RAPID CITY REGIONAL AIRPORT**ADDENDUM NO. 3**

**Request for Proposals – Integrated Terminal Technology Package
Comprising CUPPS, CUSS, MUFIDS (Including GIDS and BIDS), and Digital Backwall Video Signage
Rapid City Regional Airport**

Date of Issuance: August 12, 2026

**RAPID CITY REGIONAL AIRPORT
RENOVATION AND EXPANSION PROJECT
PROJECT 1 PHASE 3**
Rapid City, South Dakota

2 TICKET COUNTER - FRONT ELEVATION

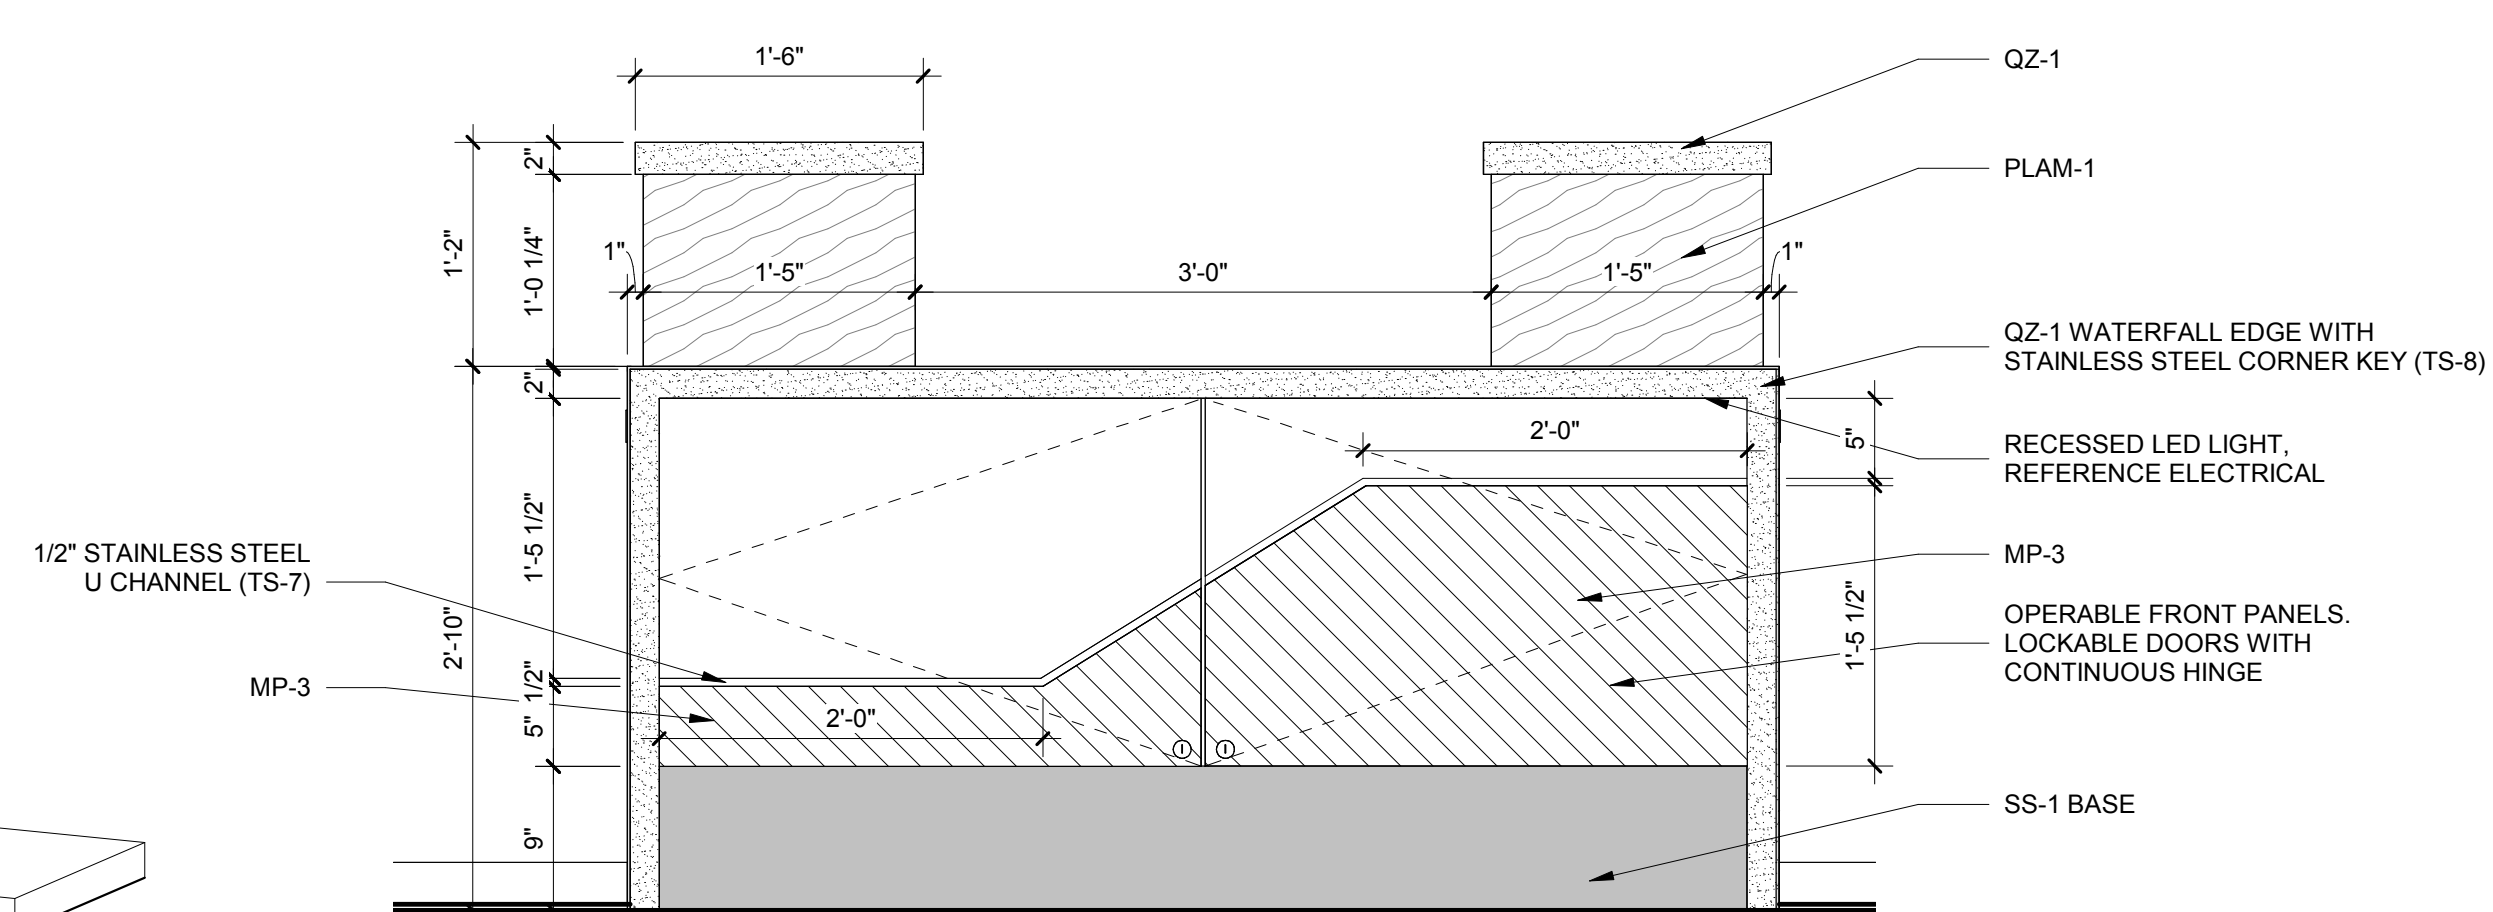
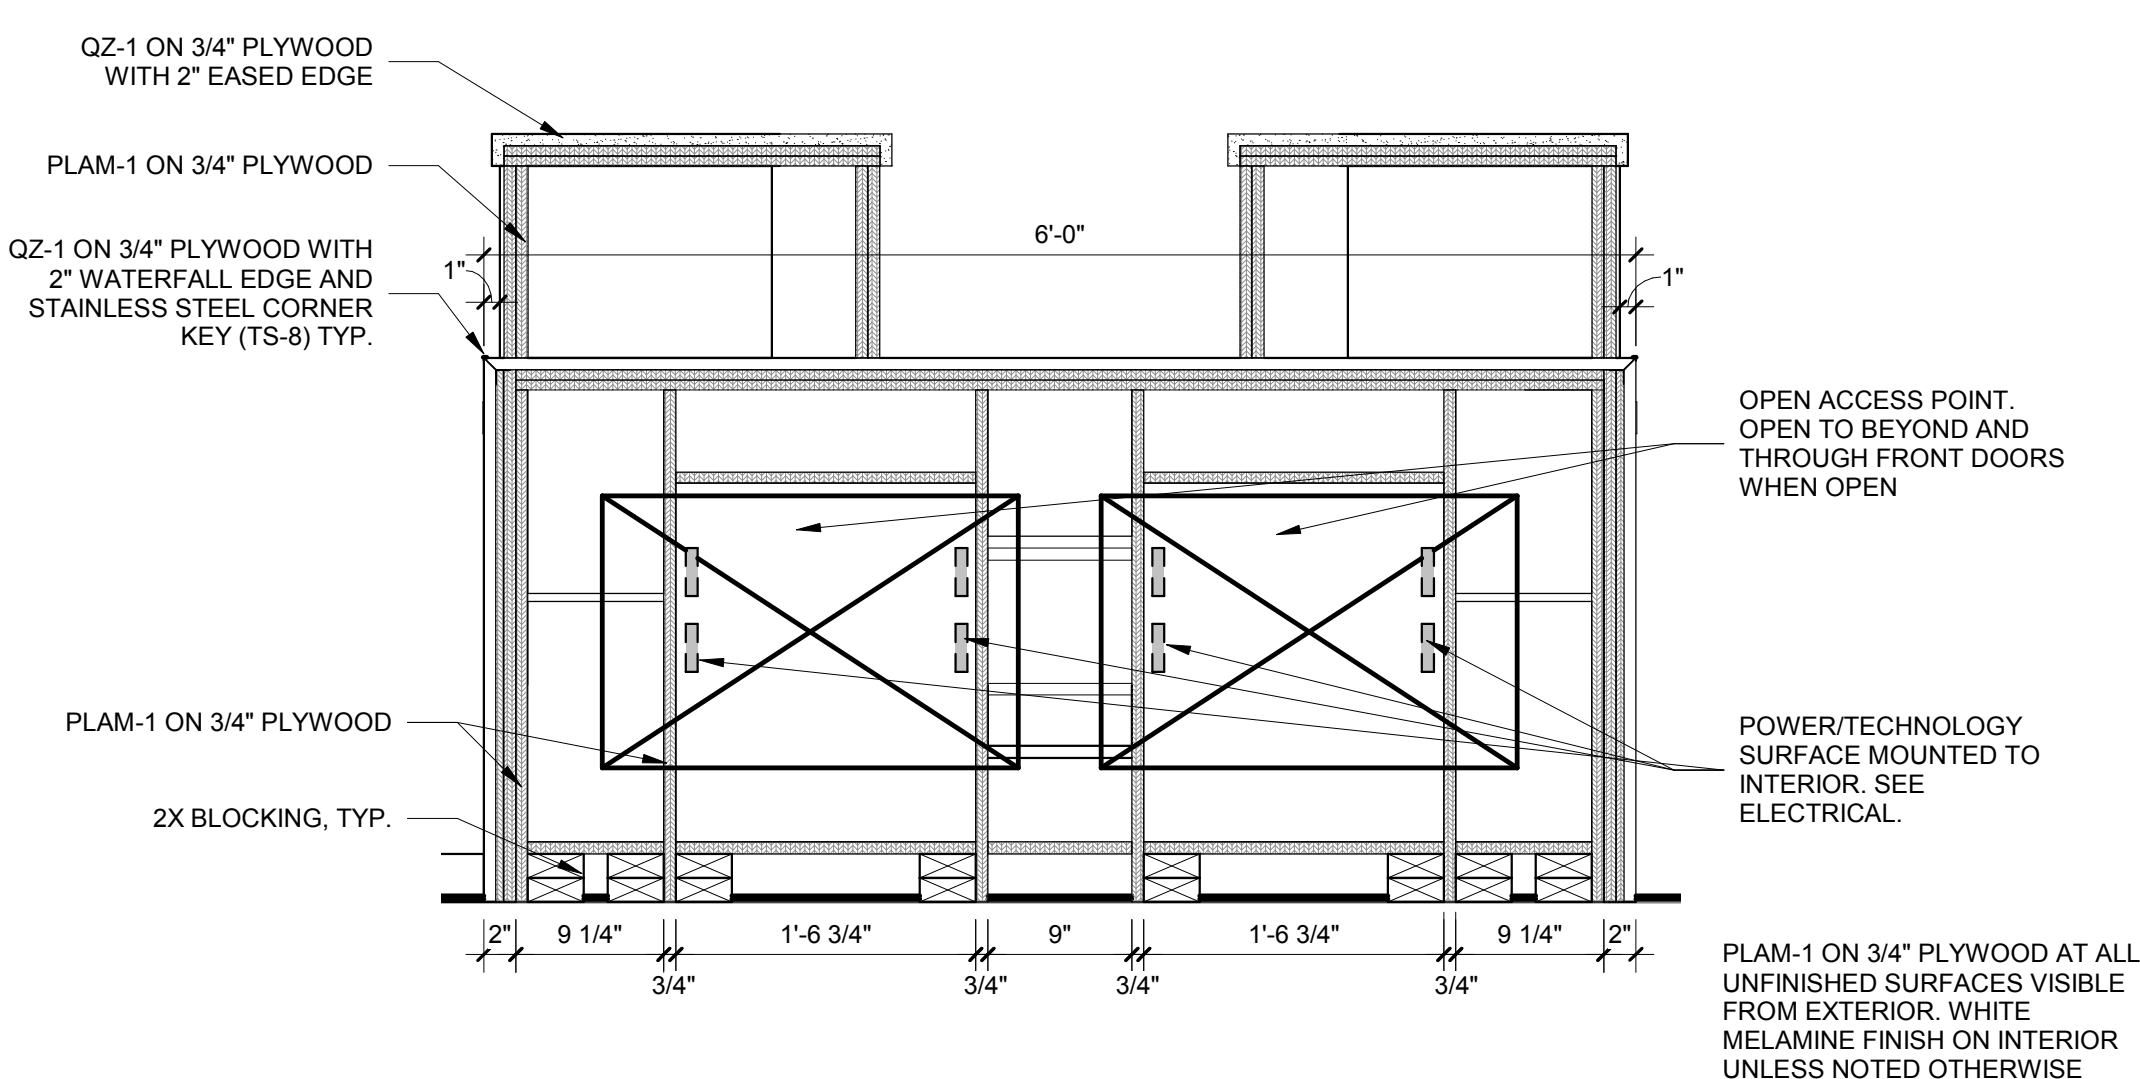
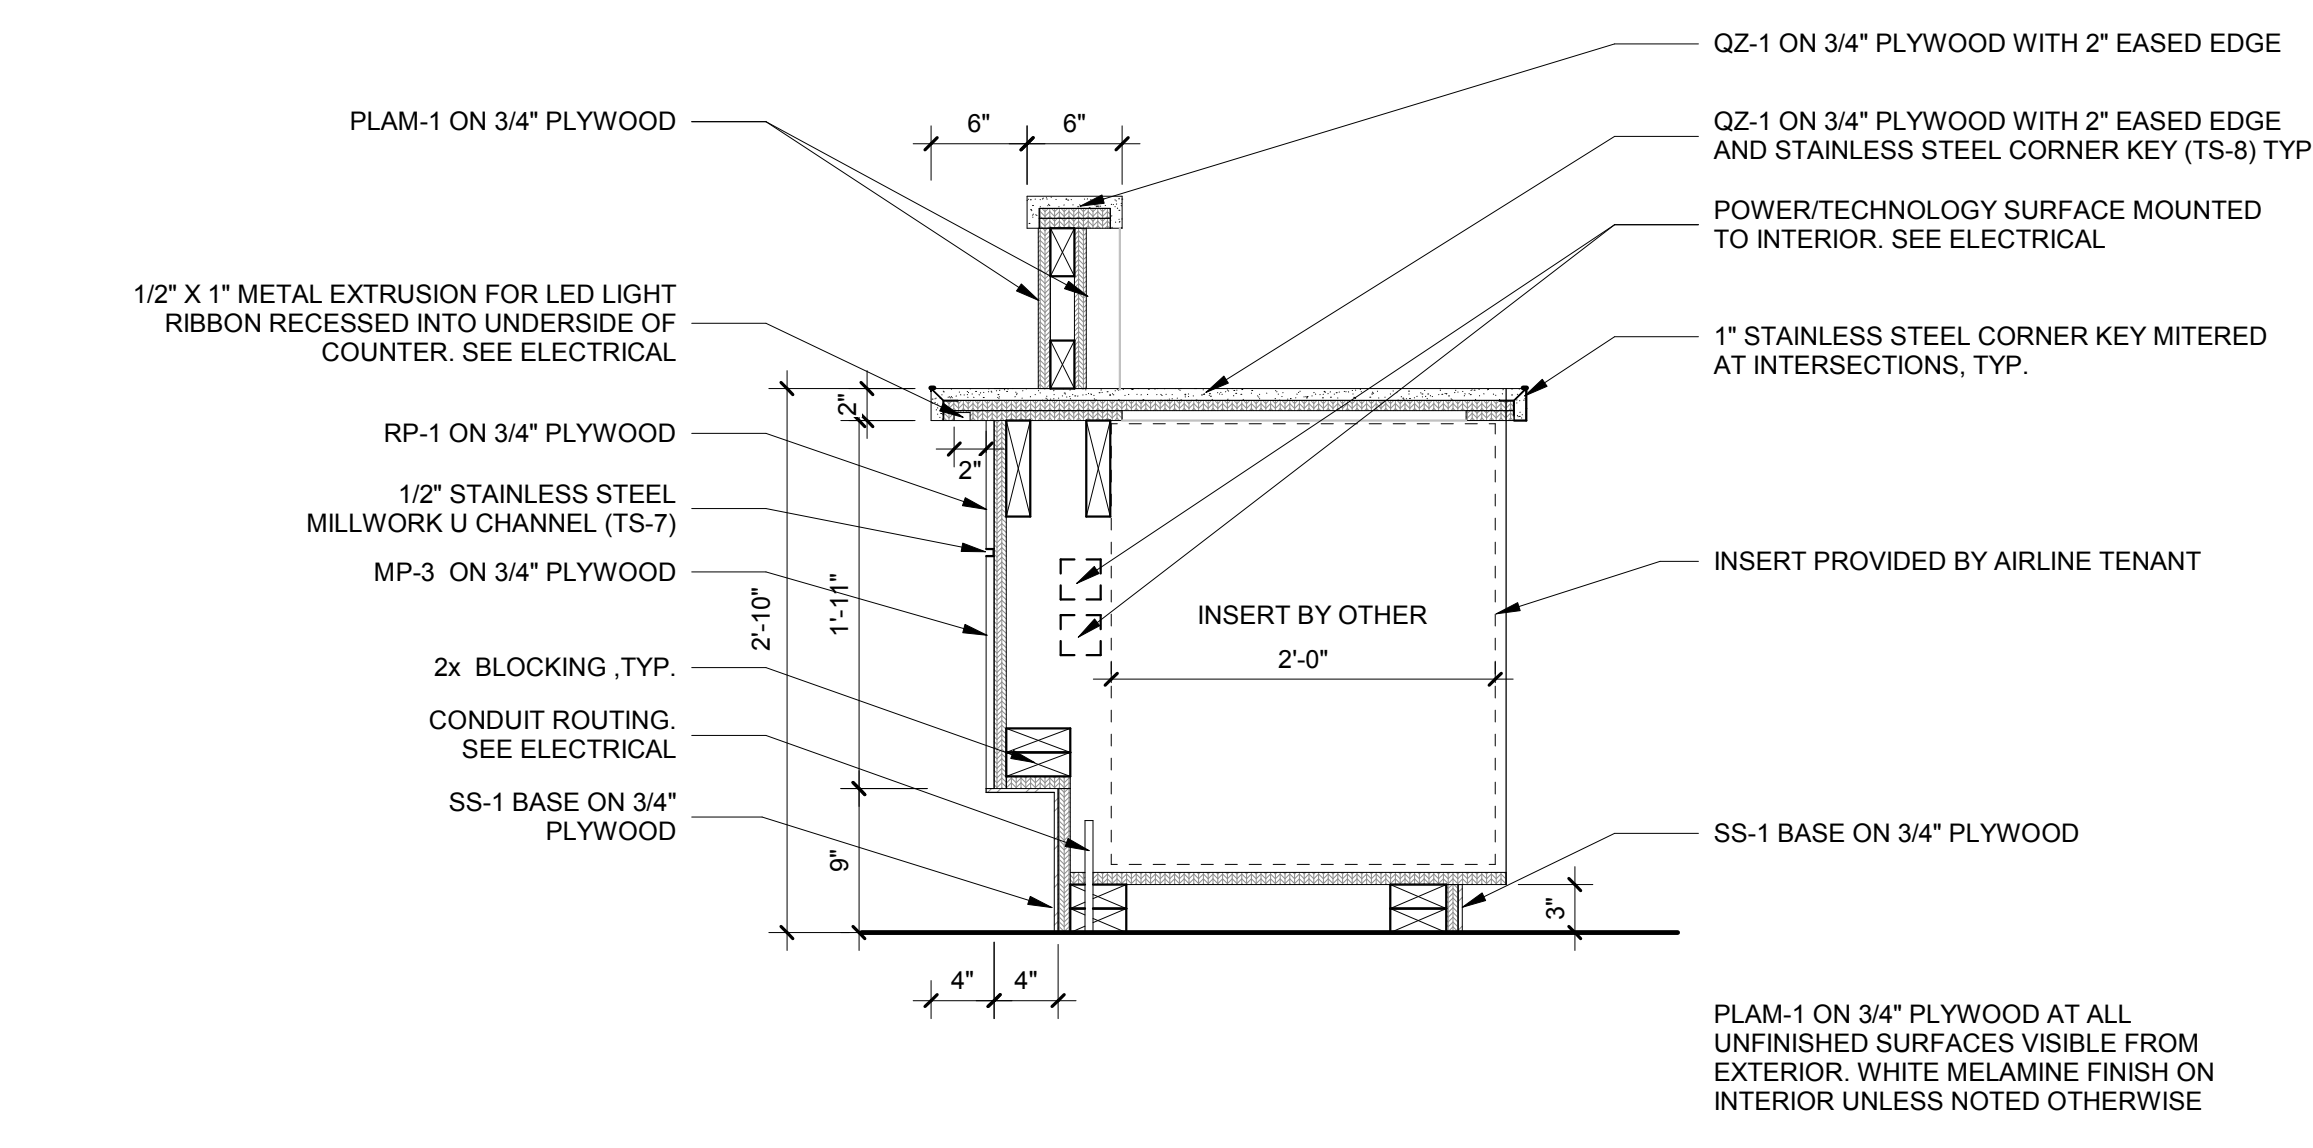
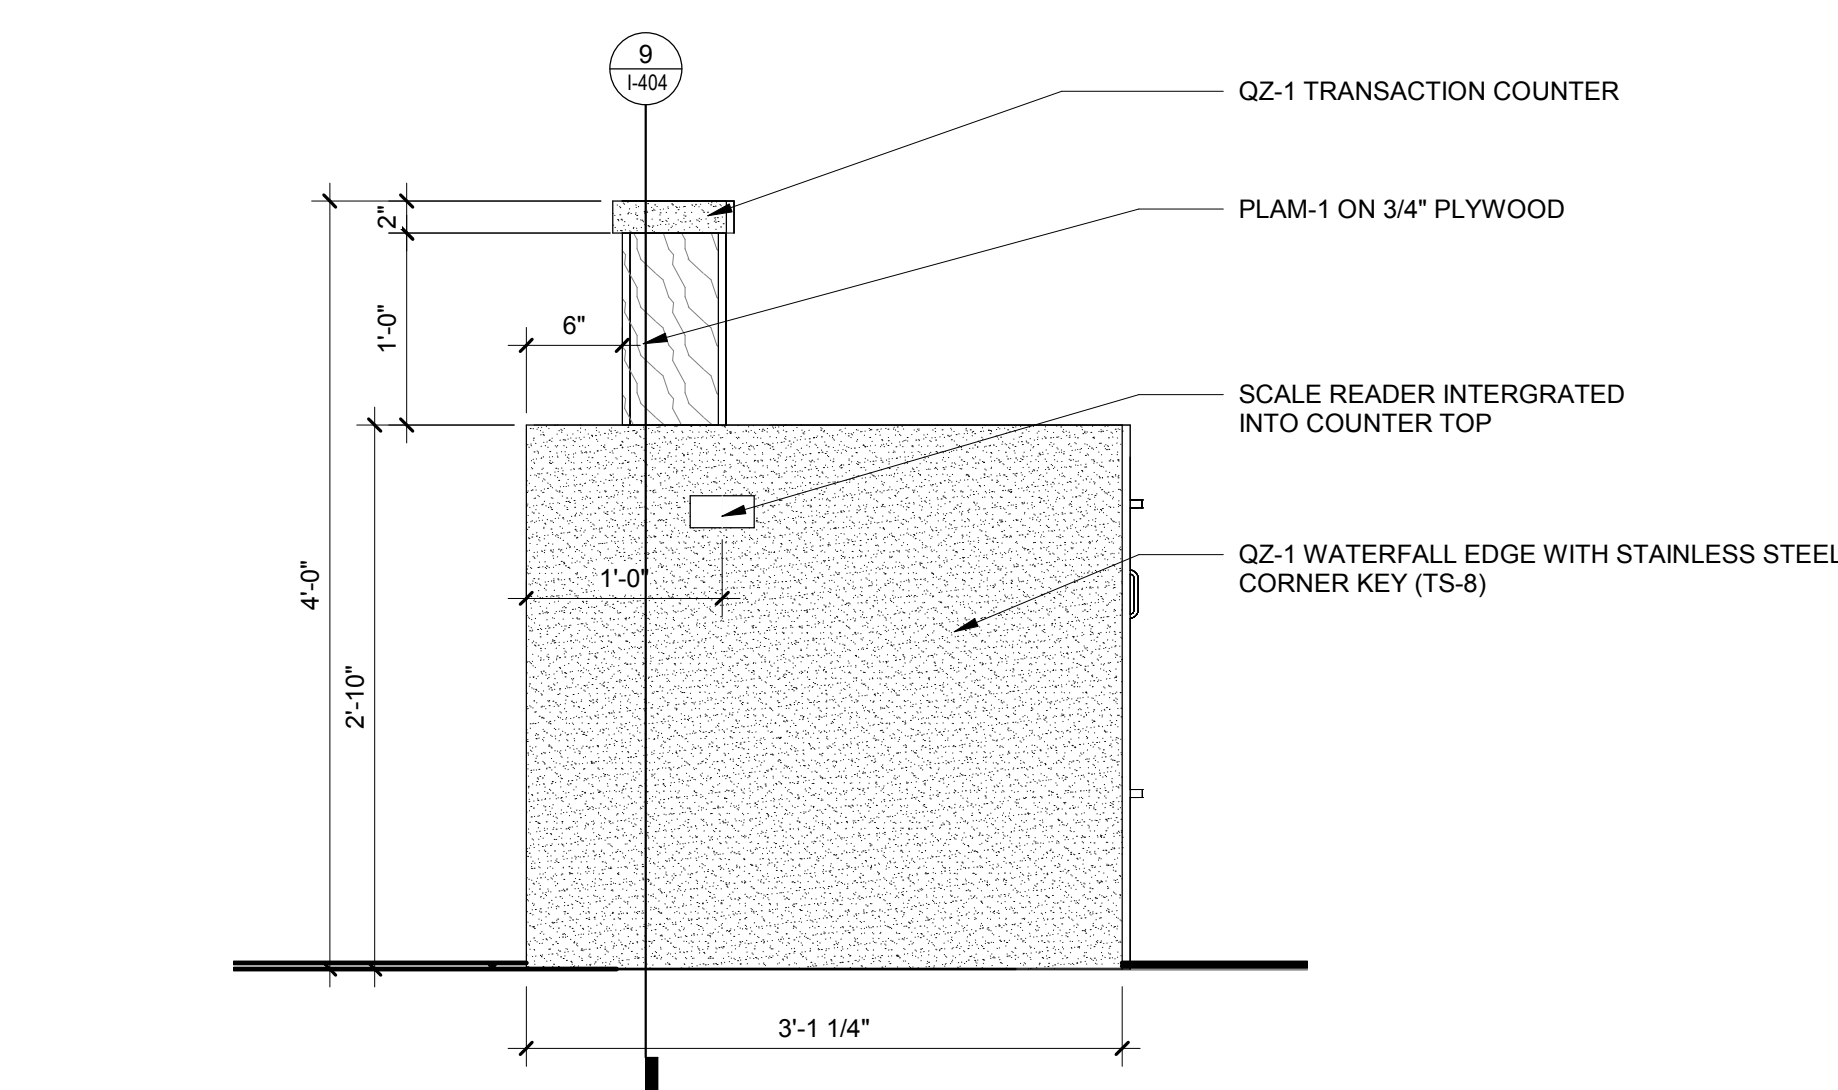
- Attachment 5 – Sheet I-404, Enlarged Ticketing Plans, Elevations, and Details. Each ticket counter module is 8'-0" wide and accommodates two agent positions, consistent with the nine-counter, two-station configuration priced under Section 5.2.1. The baggage scale is Airport-owned and Contractor-installed, with the scale reader integrated into the countertop; it is not a separate CUPPS/CUSS-furnished peripheral. Each position includes a cutout reserved for airline-provided equipment inserts, separate from the Common Use workstation footprint.
- Attachment 6 – Sheet I-407, Enlarged Gate Counter Plans, Elevations, and Details. Each gate counter module is 8'-0" wide and similarly accommodates two agent positions.

Proposers shall size Common Use workstation hardware, peripherals, and cabling to fit within the counter and gate module envelopes shown on Attachments 5 and 6.
